PLANT NAMES: Oconee Nuclear Station

Please refer to your letter of December 15, 1972 requesting additional analysis and other relevant information needed to determine the consequences of postulated failure of the main steam and feedwater pipes outside of the Reactor Building for Oconee Nuclear Station Units 1, 2, and 3.

DUKE POWER COMPANY  
 OCONEE NUCLEAR STATION  
 CONSEQUENCES OF MAIN STEAM & FEEDWATER PIPING RUPTURE  
 CURRENT STATUS OF DESIGN ENGINEERING REVIEW  
 12-29-72

POSSIBLE MODIFICATIONS TO PENETRATION ROOM  
12-29-72 PO-222

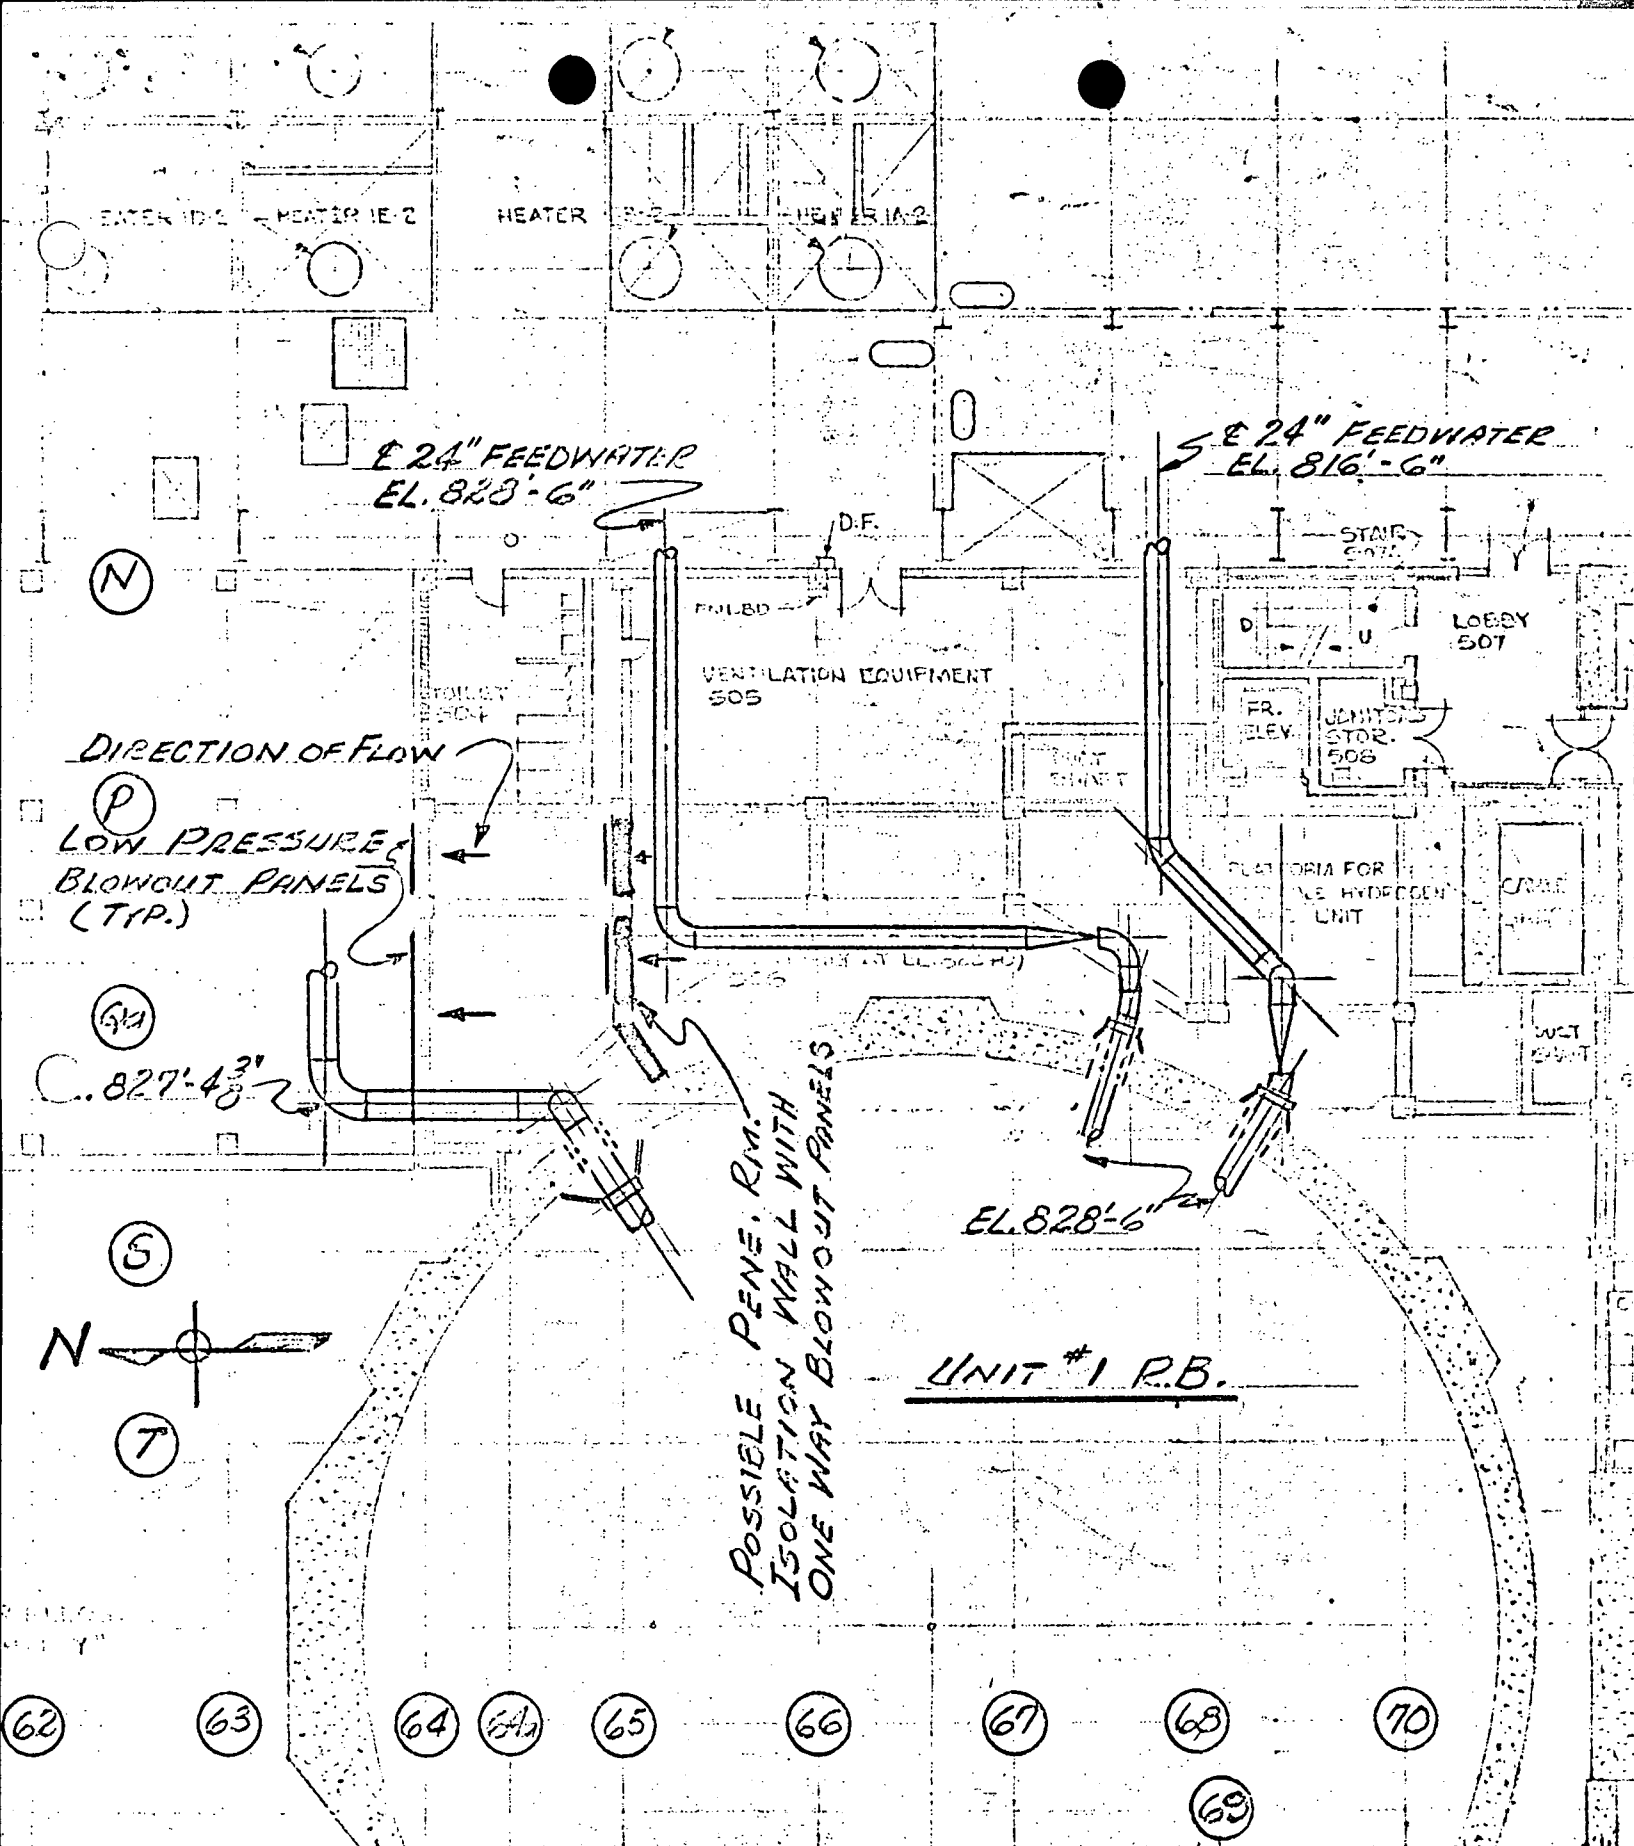
- b. East Steam Generator Main Steam Line. This line leaves the Reactor Building wall and passes through one corner of the East Penetration Room as shown on attached Sketch P0-222. Postulated pipe whip, jet impingement or reaction forces resulting from failure of this line would not damage any equipment necessary to shut down safely and maintain the reactor in a safe shutdown condition. However, pressure effects and steam concentrations might possibly pose a problem in the penetration room.

- c. East and West Main Feedwater Lines. These lines enter the Reactor Building through the East Penetration Room as shown on attached Sketch P0-222. Postulated failure of either of these lines could damage several auxiliary systems and related electrical components due to pipe whip, jet impingement and reaction forces. Feedwater for secondary side cooling is assured to the unaffected Steam Generator by either the steam-driven Emergency Feedwater System or the backup Auxiliary Service Water System. Pressure effects and steam concentrations could pose a problem in the penetration room. Since the postulated failure can occur on either the upstream or the downstream side of the Reactor Building isolation check valve, both cases are being analyzed.

At present, possible modifications to the station to reduce the effects of pressure and steam concentrations as described in 4)b. and 4)c. to acceptable limits are being analyzed.

- a. East Steam Generator Main Steam Line. As shown on the attached Sketch P0-222, the existing north penetration room wall may be modified to include low pressure blowout panels to relieve pressure and to provide a steam escape route for the postulated failure of this line. The addition of a new wall to remove the main steam line from the penetration room environment may be added along Column Line 65 as shown on Sketch P0-222.
- b. East and West Main Feedwater Lines. One way low pressure blowout panels may be added to the new wall along Column Line 65 to relieve pressure and provide a steam escape route for the postulated failure of these lines.
